### Proposed Revisions to a Standard Plans Index

Index Number: 700-012

Index Title: Single Post Bridge Mounted Sign Support

All Sheets: Renamed Index "Single Post Sign Support Barrier Side-Mounted".

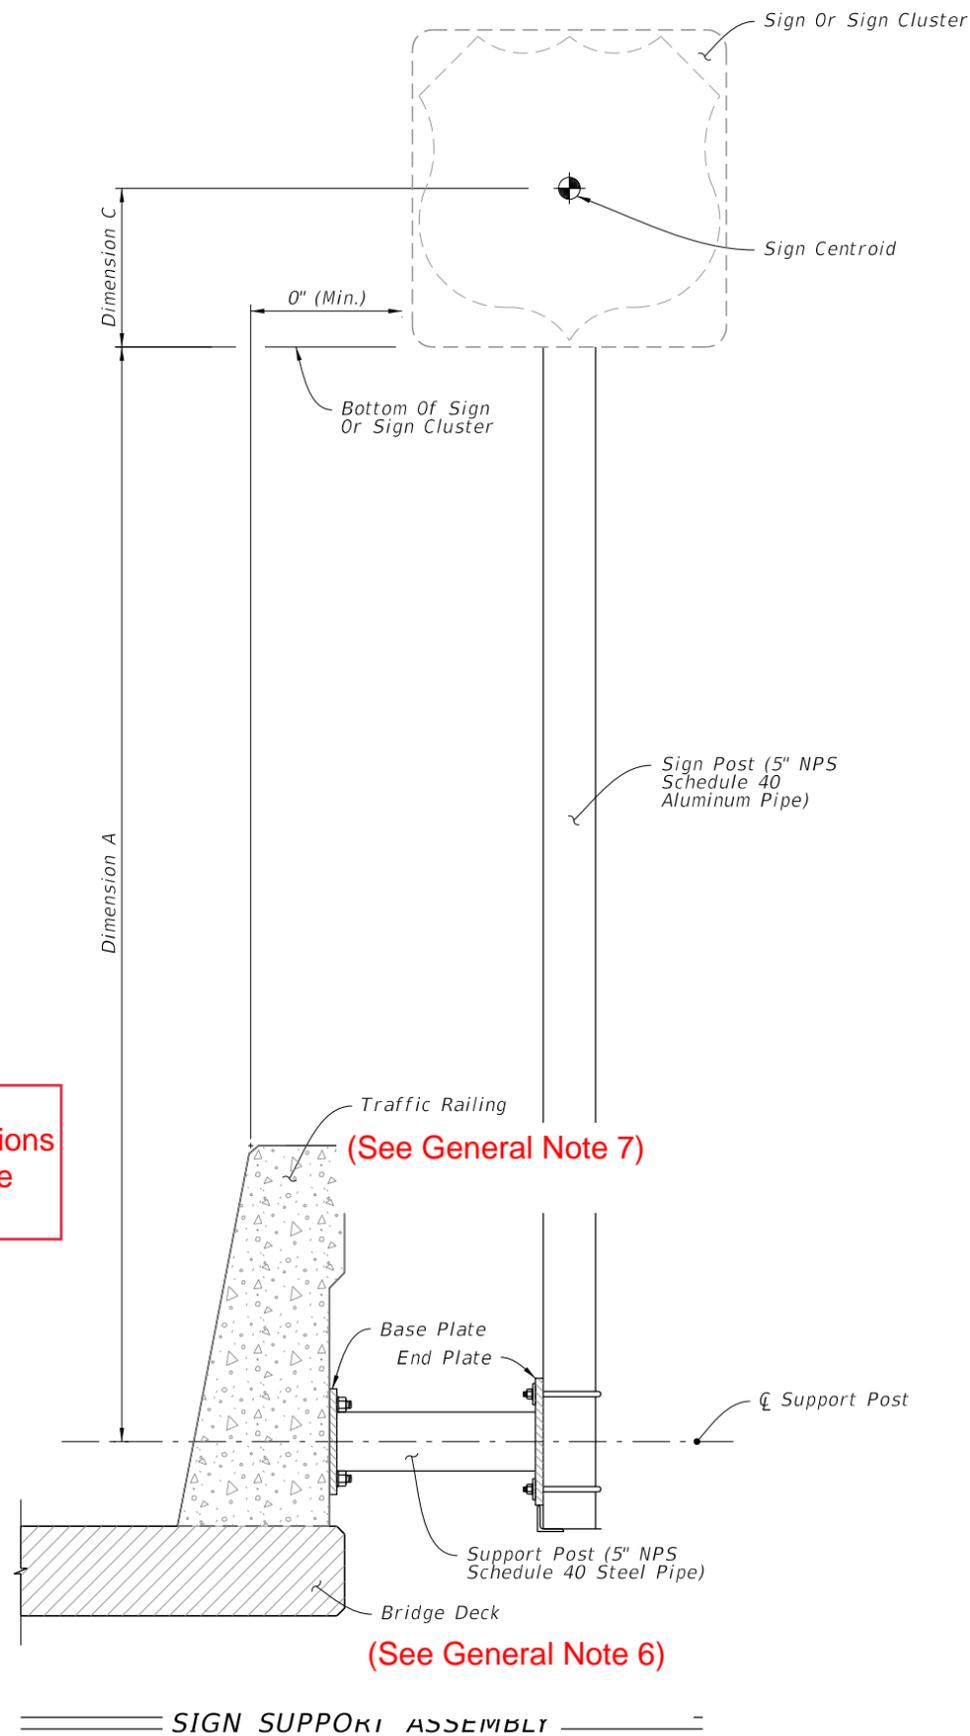
**UPDATED: GENERAL NOTES:**

**ADDED NEW NOTE 1: Meet the requirements of Specification 700.**

**DELETED**

**GENERAL COMMENT: Material and fabrication information was deleted. Information is either already covered in Standard Specifications OR will be added to Section 700, 962 or 965 in conjunction with these revisions.**

**DELETED**

**ADDED NEW NOTE 6 AND 7 FROM SHEET 2:**  
 6. Bridge deck shown. Approach slabs, junction slabs, and miscellaneous structures are similar.

7. Traffic railings are shown. Concrete barriers and parapets are similar.

**CHANGED TITLE:**  
 Single Post Sign Support Barrier Side-Mounted

LAST REVISION	DESCRIPTION:
11/01/17	
11/01/22

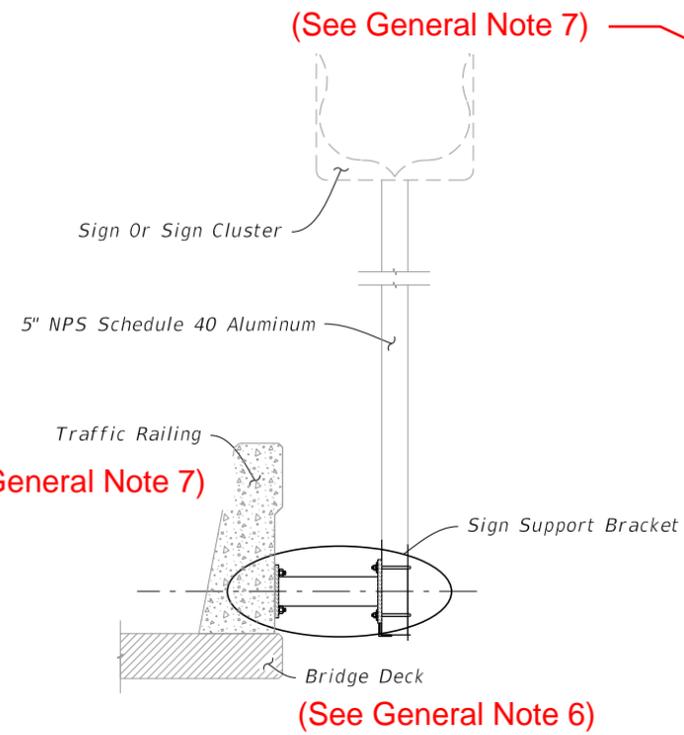
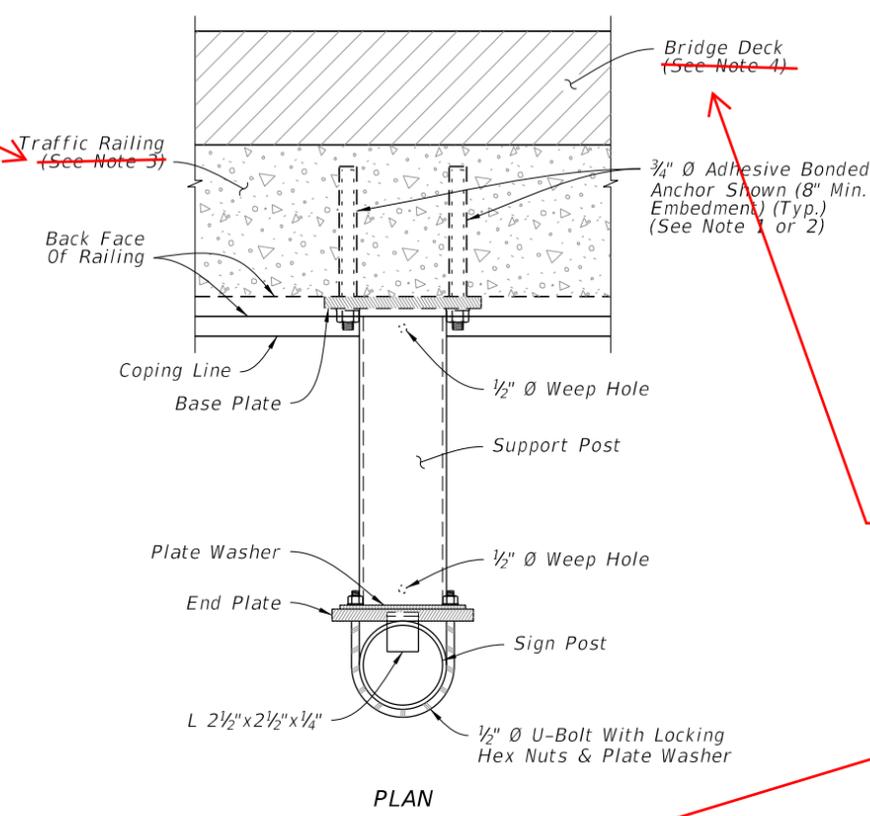
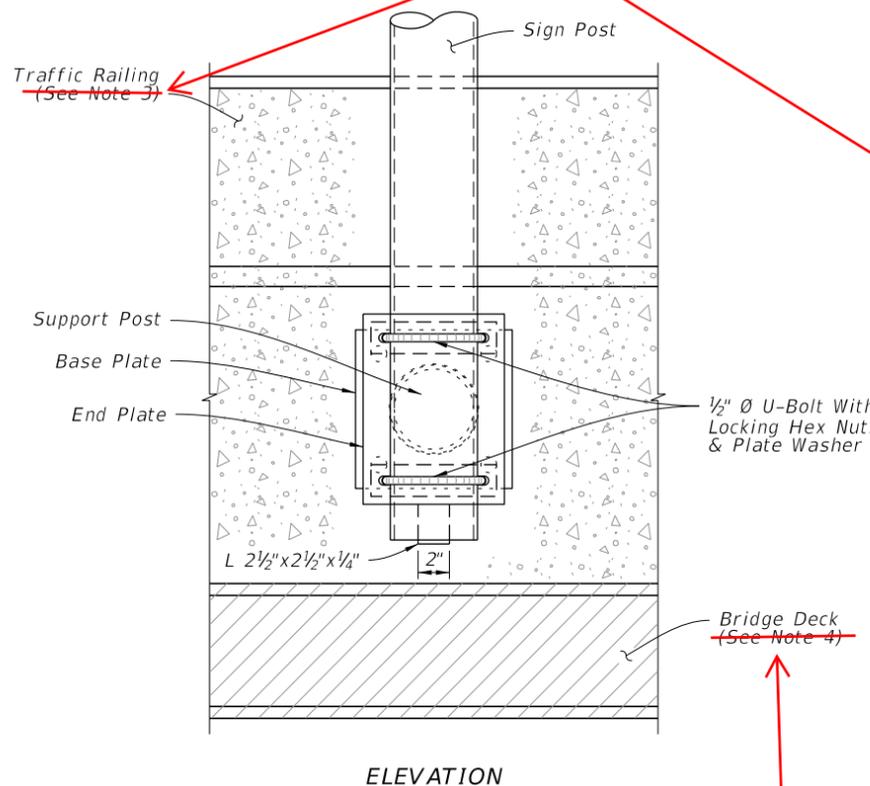
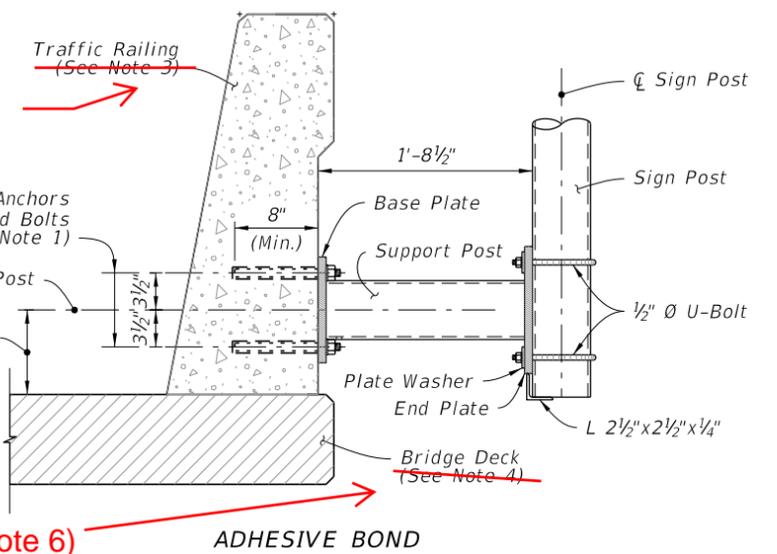
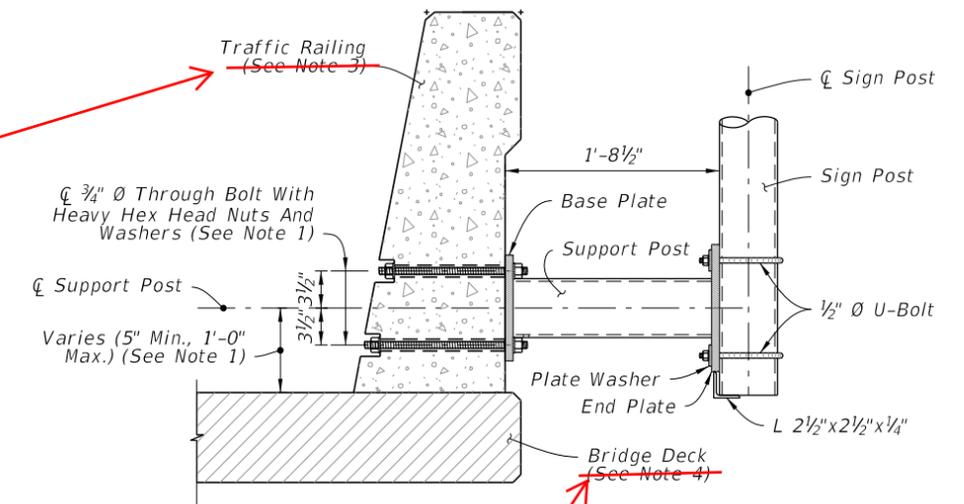
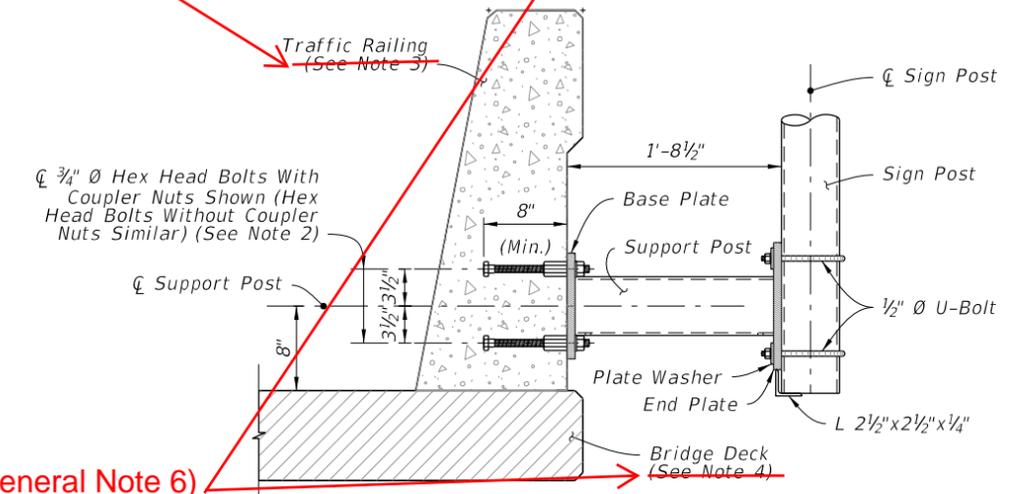
(See General Note 7)

(See General Note 6)

MOVED TO GENERAL NOTES

CHANGED TITLE:  
Single Post Sign Support Barrier Side-Mounted

SHEET  
 3 of 3

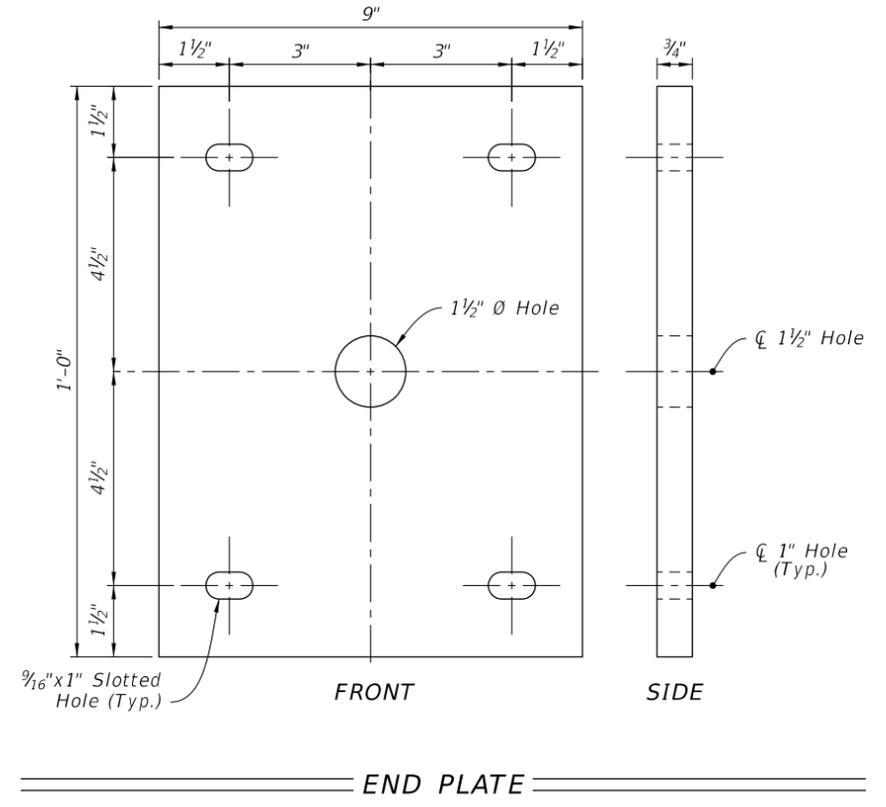
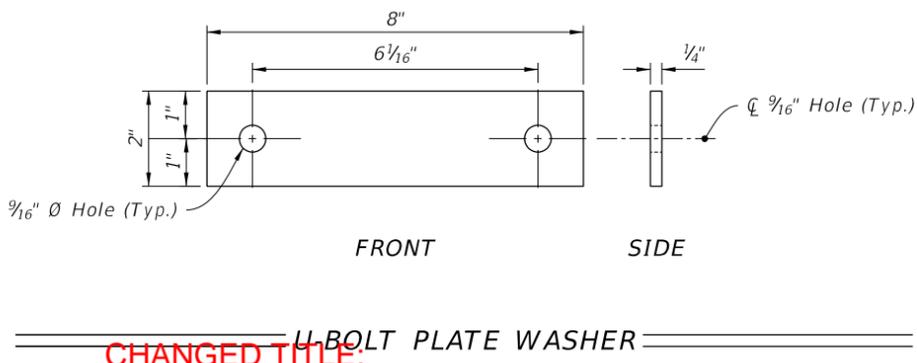
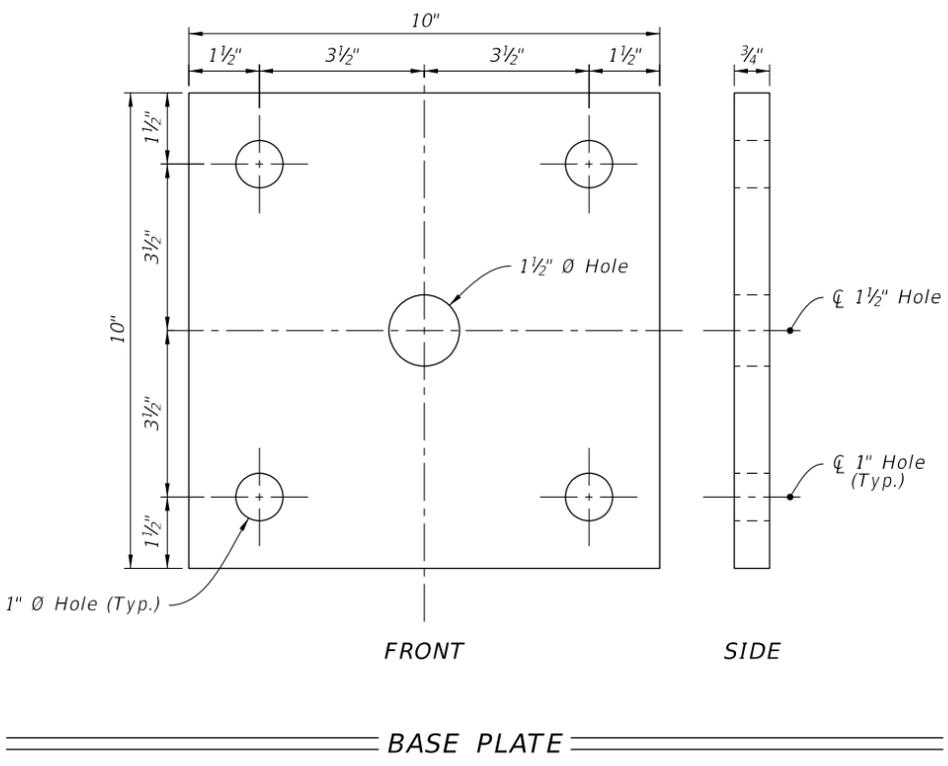
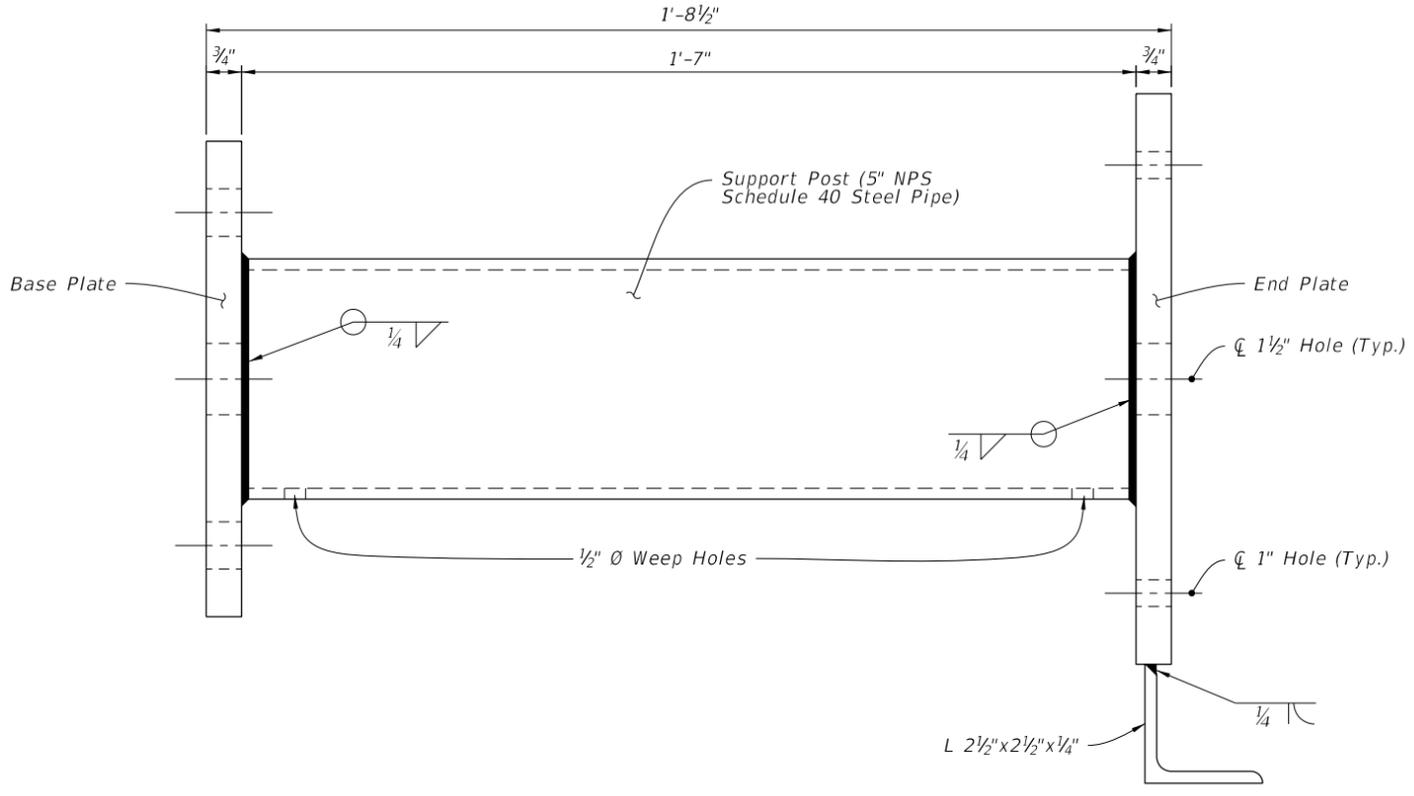
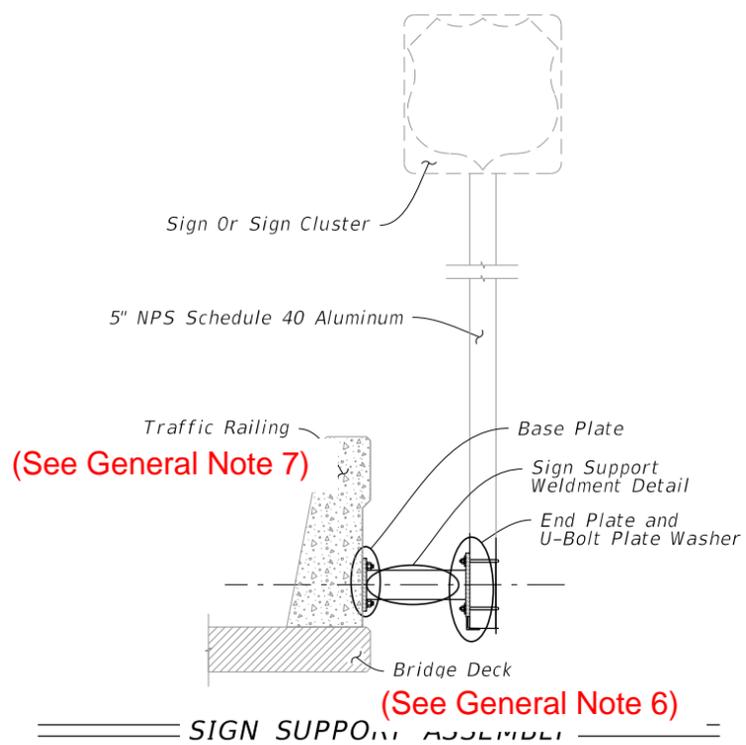
~~SINGLE POST BRIDGE MOUNTED SIGN SUPPORT~~  
 CHANGED TITLE:  
 Single Post Sign Support Barrier Side-Mounted
